**TEMPORARY CORRECTION T-1 TO TECHNICAL MANUAL FOR  
RADIO RECEIVER R-390A/URR  
NAVSHIPS 93053**

This temporary correction revises the manual to reflect the equipment changes made by Field Change 3-R-390A/URR. The purpose of this field change is to alter the electrical access at the rear of the receiver from terminal strips (TB102, TB103) to "AN" type connectors. If it becomes necessary to remove the receiver from its cabinet, it will be necessary only to unfasten three connectors instead of the individual wires at the terminal strips. The field change applies to all R-390A/URR receivers, all serial numbers.

FIGURE I.

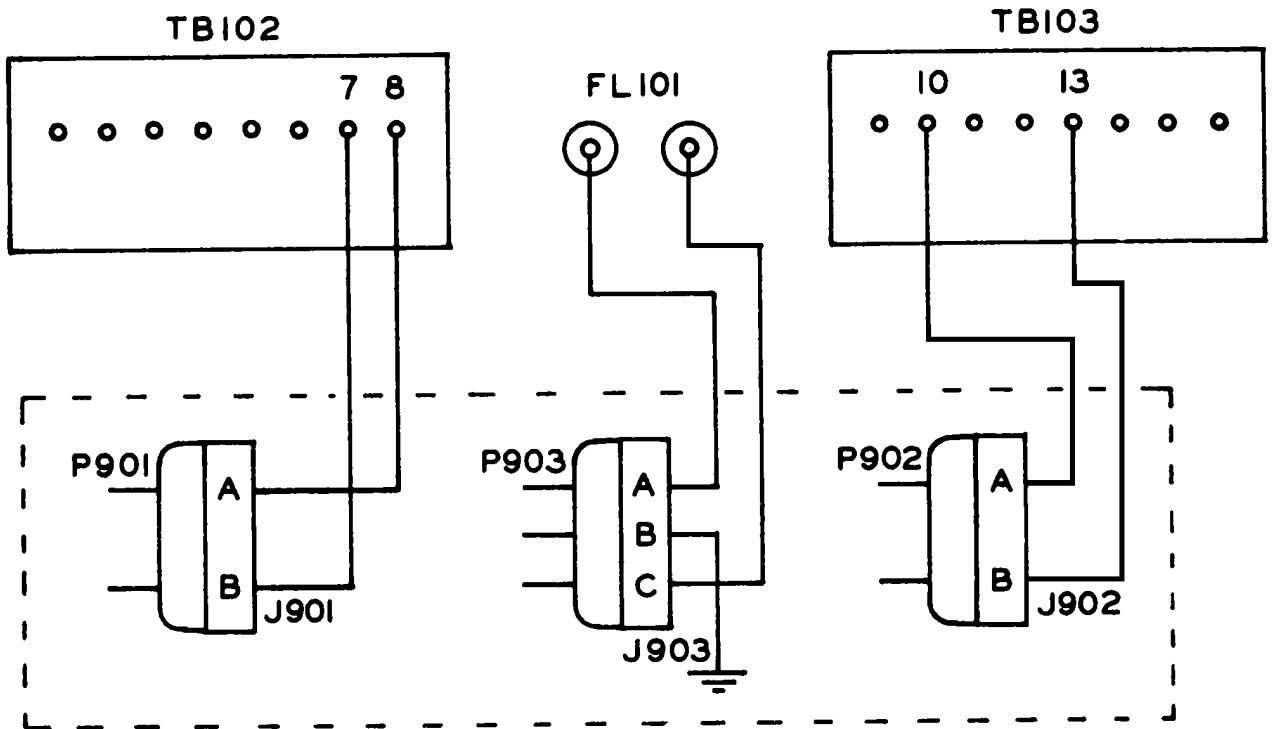
<u>PAGE NO</u>	<u>PARA &amp; LINE or FIG &amp; LOCATION</u>	<u>ACTION</u>
Volume I		
11	Figure 7	Add: "This panel is now modified. See Figure 1 of this correction."
Volume II		
9	Figure 5	Delete those parts of the illustration associated with: <ul style="list-style-type: none"> <li>(a) "600 ohm speaker"</li> <li>(b) "To 115/230 volts AC 48 to 62 CPS"</li> <li>(c) "Balanced 600 ohm audio line to auxiliary equipment"</li> </ul>

The cables are now terminated with "AN" plugs which are connected to the receptacles shown in Figure 1 of this temporary correction.

126	Figure 75	Delete "16 GND" and add: "Ground common lead at any convenient point on the receiver."
130	Figure 76	Add: "Connections to terminal strips TB102 and TB103 must be made from inside the receiver."
134	Figure 77	Same as Figure 76.
140	Figure 79	Same as Figure 76.
142	Figure 80	Same as Figure 76.
179	Figure 89 (Sheet 2)	Add: "For wiring of connector channel on back panel of receiver, see Figure 1 of this correction.  It is recommended that Figure 1 be inserted between Figure 89(1) and Figure 89(2)."

J901 IS MS3102A10SL-4P  
 J902 SAME AS J901  
 J903 IS MS3102A16S-5P

P901 IS MS3108B-10SL-4S  
 P902 SAME AS P901  
 P903 IS MS3108B-16S-5S

P901-P902 HAVE CABLE CLAMP MS3057-4  
 P903 HAS CABLE CLAMP MS3057-8
